# SERVICE LETTER

No. 707

Subject: Modified Flyball Assembly to Improve RPM Control  
-- reference attached Hartzell Service Letter No. 75,  
dated November 16, 1973.

SERVICE LETTER NO. 75

A-153(A)-(C) FLYWEIGHT (SEE CHART)  
(MATERIAL GROUND FROM  
SIDES ON "A" MODIFICATION)

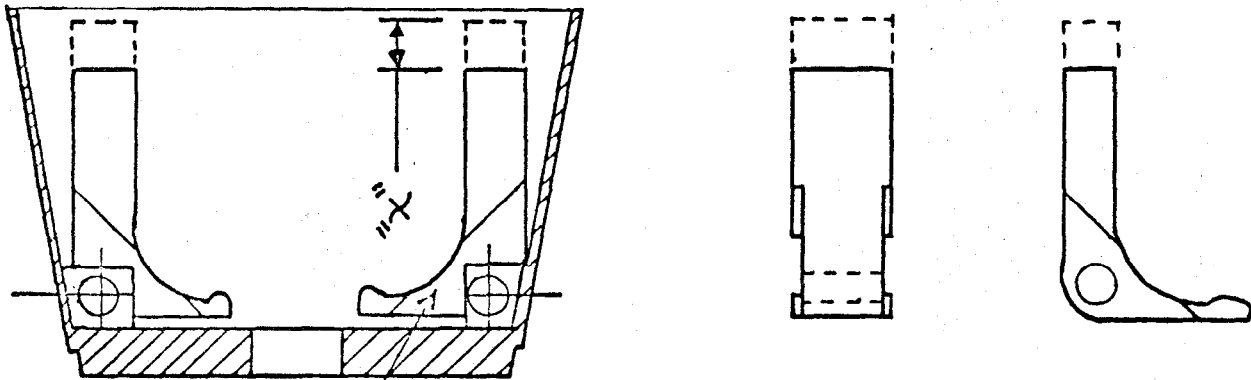
Discussion: To effect an improved RPM control on aircraft with the Hartzell governors, a modified flyweight assembly designed to absorb the torsional motions of the drive gear are being installed in all Hartzell production governors.

- 1) Determine flyweight assembly needed using parts listed in this letter.
- 2) The flyweight assembly can be changed by:
  - a) removing cover assembly
  - b) removing flyweight assembly locking ring
  - c) removing flyweight assembly
  - d) placing new flyweight assembly in place
  - e) replacing lock ring, making sure it is in place
  - f) replacing cover gasket 50672, and
  - g) installing cover assembly

A-153A-2	0	1600-2800
A-153A-1	.250	2500-3700
A-153A	.462	3200-4350
A-153-2	0	1600-2800
A-153-1	.250	2500-3700
A-153	.462	3200-4350
PART NO.	X" LENGTH REMOVED	RPM RANGE
